ADDENDUM NO. 1

Project Name:	Charlottesville-Albemarle Airport Mechanical Systems Upgrades
RS&H Project Number:	20541892009

DATE OF ISSUANCE: June 28, 2024

6/28/2024 2:44:49 PM Autodesk Docu//20541812009_CHO Mechanical Systems Upgrade_MP_R22.dwg

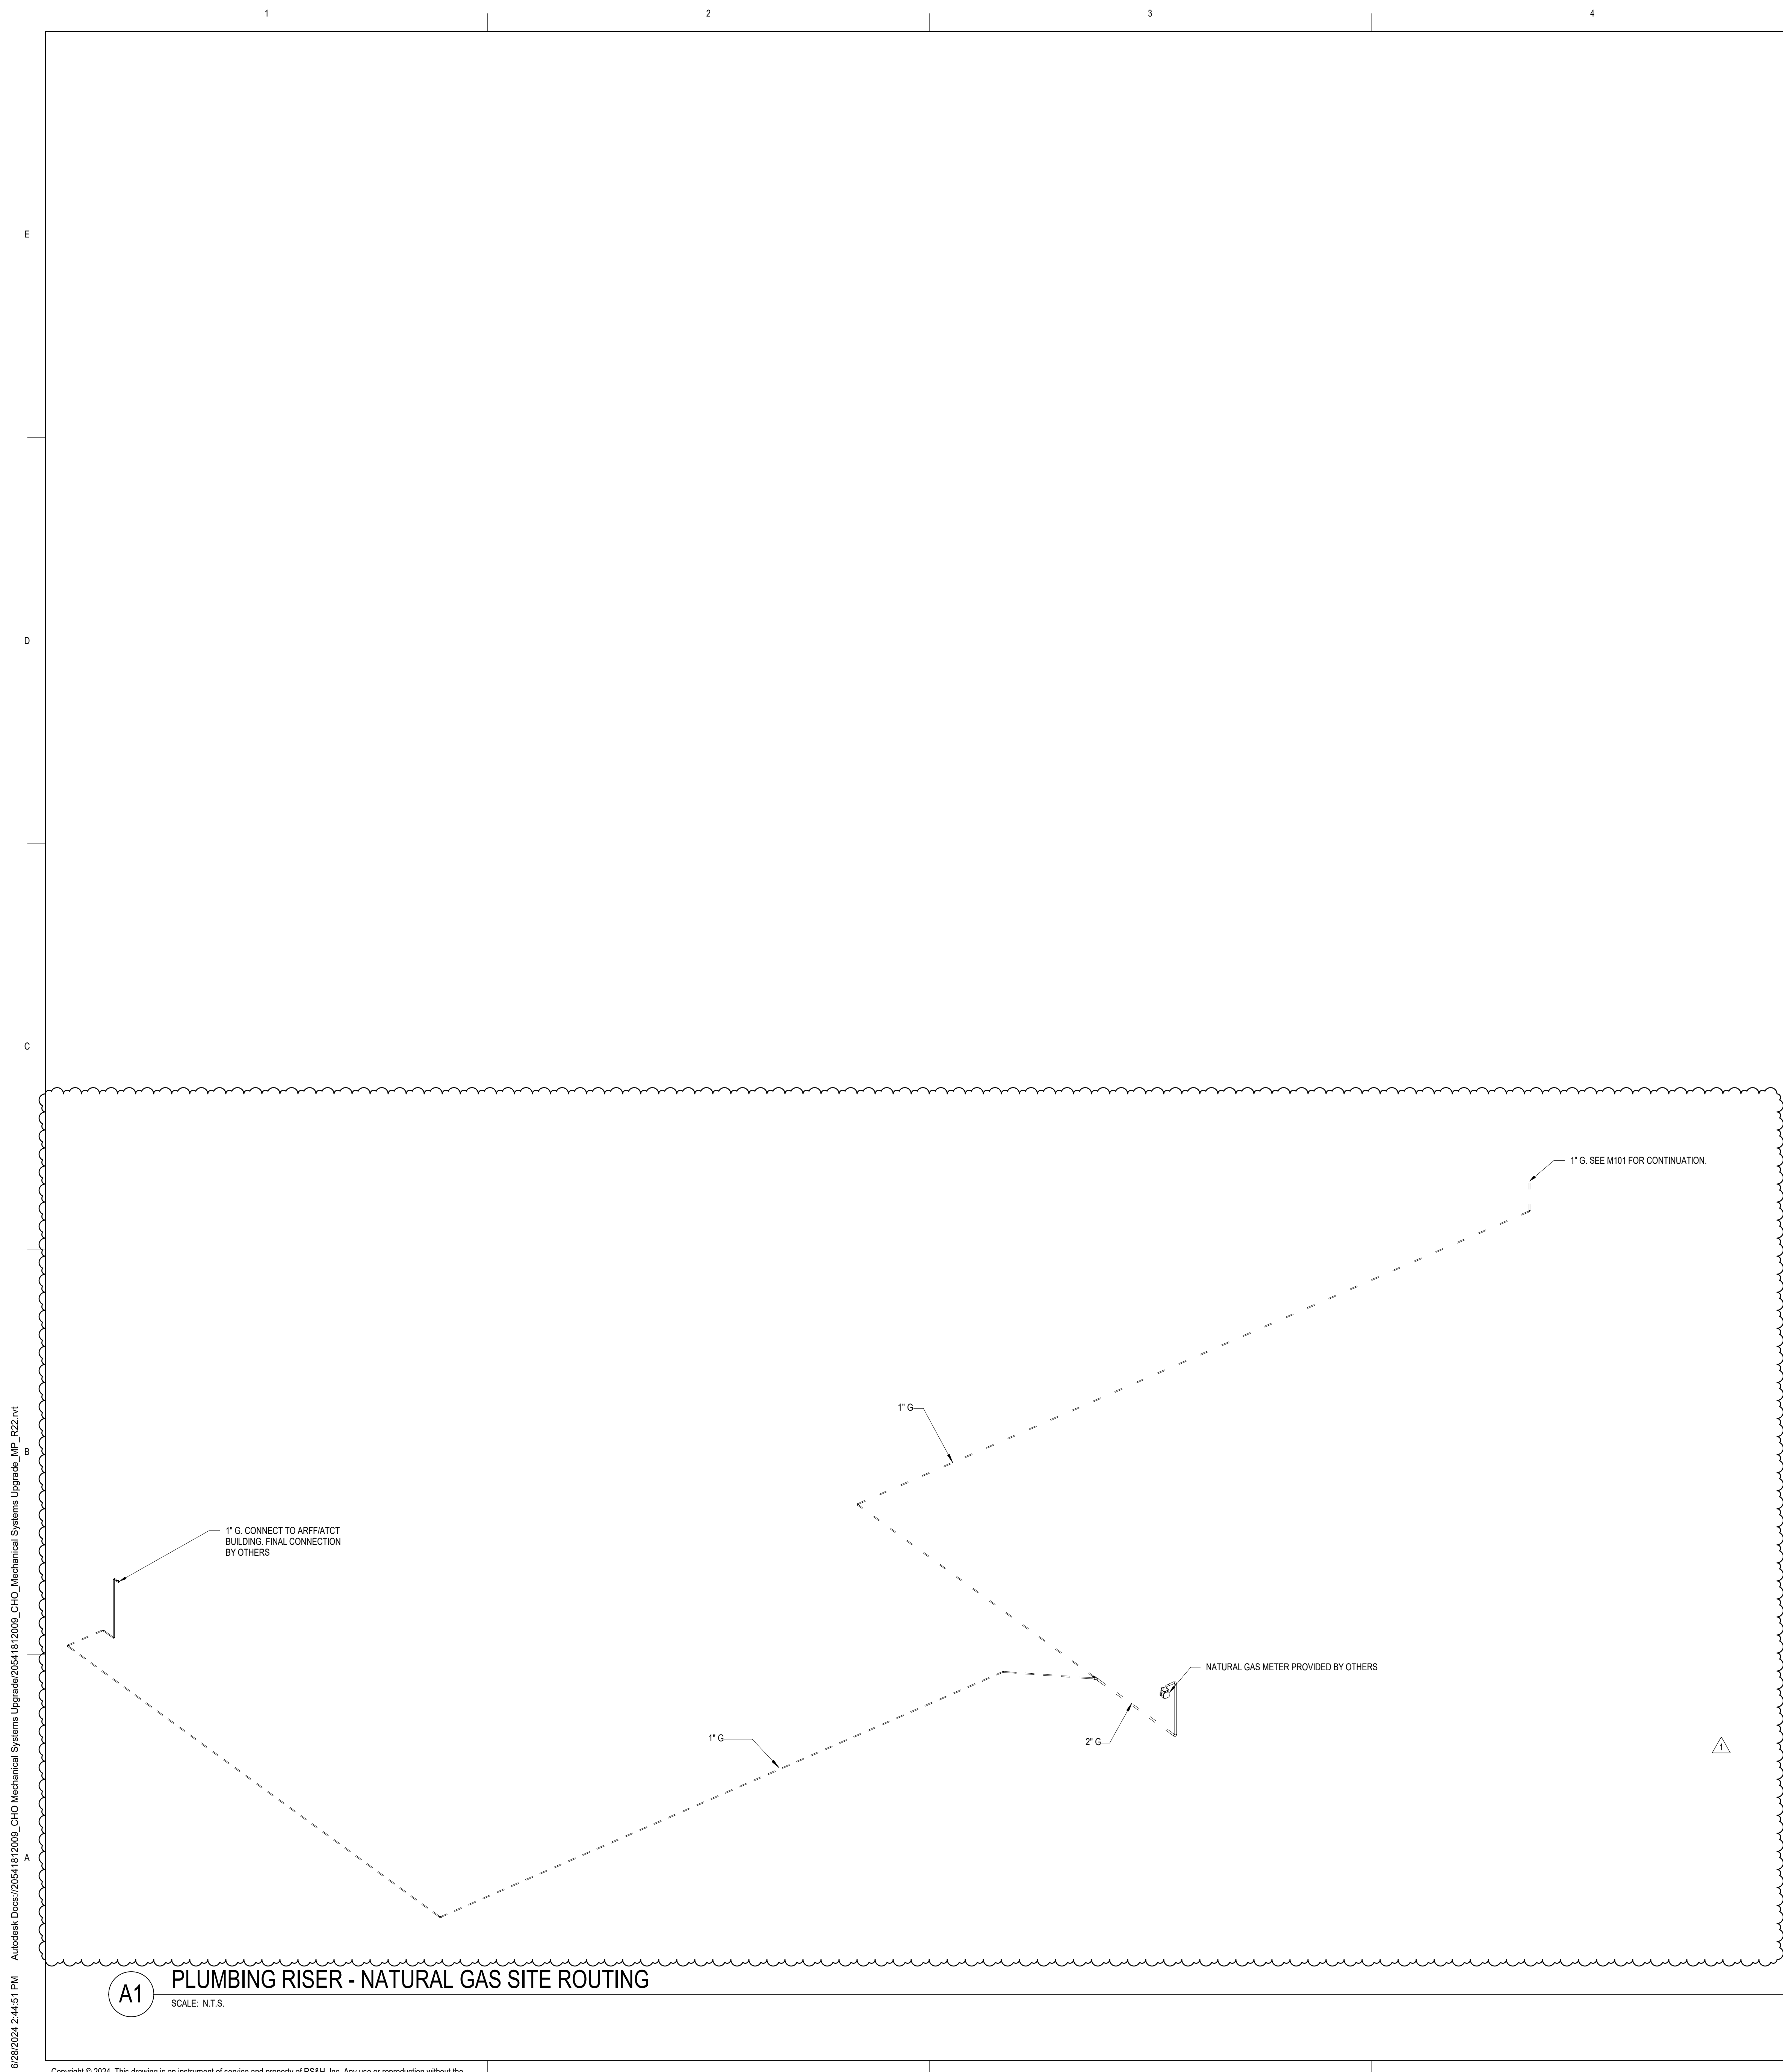
15	Drawing M501 – Detail A3 calls for a “Pressure Relief Valve”, and “Backflow Preventor”, are these existing to remain, or new? If new please provide specifications.	Details were applicable to a previous scope of work that has been removed. Details have been deleted. See revision in Addendum #1.
16	Drawing M501 – Detail B3 shows a “Aquastat”, “Circulating Pump”, and “Balancing Valve” are these items existing to remain, or new? If new please provide specification.	Details were applicable to a previous scope of work that has been removed. Details have been deleted. See revision in Addendum #1.
17	Drawing M501 – Detail A1 shows a “Balancing Valve”, and “Check Valve”, we have not found a specification for these items, please provide.	Details were applicable to a previous scope of work that has been removed. Details have been deleted. See revision in Addendum #1.
18	Drawing M801 shows “Setter”, “Balancing, Butterfly, and Check Valves” we have not found a specification in Division 23 for these items, are they existing to remain? If not please provide specification.	Setters and other valving not applicable for controls diagram. See revision in Addendum #1.

B1 END SUCTION PUMP DETAIL
 SCALE: N.T.S.

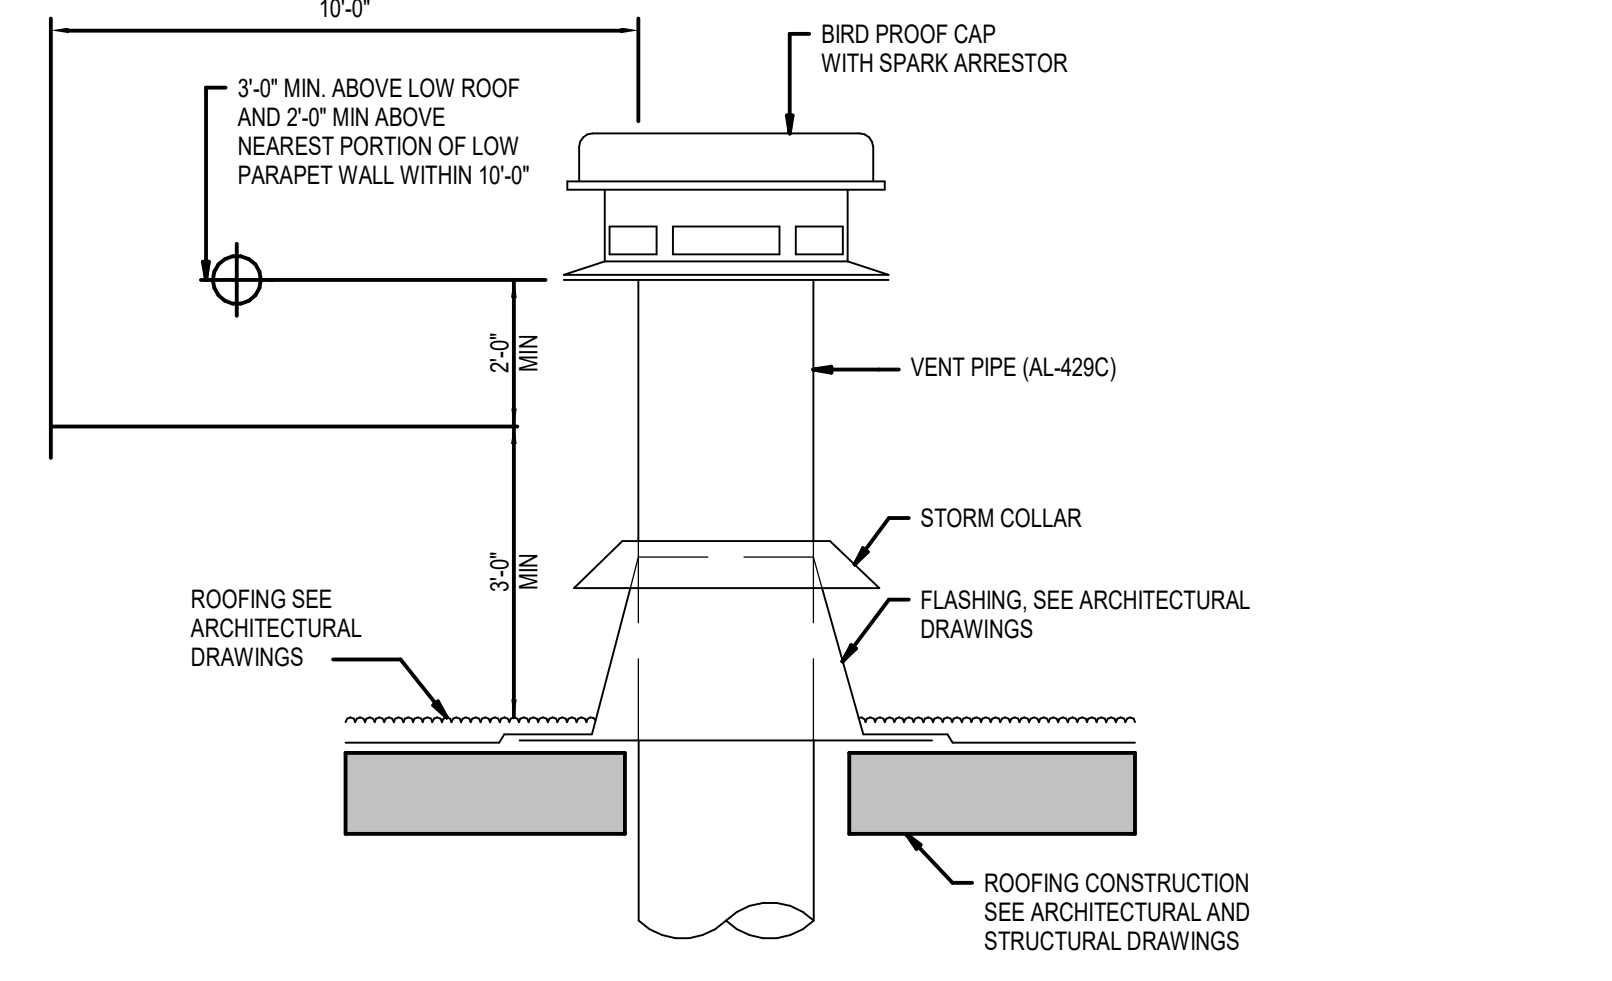
38	Regarding Drawing M501 End Suction Pump Detail: Can a triple duty valve be used instead of check & balancing valve?	Use of a triple duty valve in lieu of the check and balancing valve is allowed.
39	Throughout the drawings, there are several butterfly valves shown which are labeled as gate valves. Please confirm if butterfly or gate valves are required.	Details were applicable to a previous scope of work that has been overcome by events. Any new valves required are to be butterfly valves or ball valves dependent on pipe size. See revision in Addendum #1.
40	Does the existing boiler water mechanical system have a chemical treatment? If yes, please confirm whether shot feeder can be reused, and please provide the name of the chemical treatment provider?	See response to Question #8 & #9 above for existing treatment system and contractor information. Existing shot feeder can be reused.
41	Drawing M501 Detail C2 & Detail B3 show two different types of expansion tanks. Please confirm which type/detail is correct and indicate on the drawings where the expansion tanks and air separator are to be installed.	Details were applicable to a previous scope of work that has been removed. Details have been deleted. Expansion tank and air separator are existing to remain. See revision in Addendum #1.

46	Please confirm pipe material for underground gas pipe.	The underground gas pipe material is sch 40 steel.
47	Regarding Drawing M501 Detail B1: Are pump isolators required in addition to pipe flex connectors?	Provide as shown in detail B1.
48	Specification 221223.11 calls out the necessity to provide water. Will the owner allow us to use on-site potable water for filling, flushing, and testing?	On-site potable water is available for filling, flushing, and testing.
49	Specification 225233-11 references section 235123. Please provide specification 235123.	Specification 235123 has been included. See revision in Addendum #1.
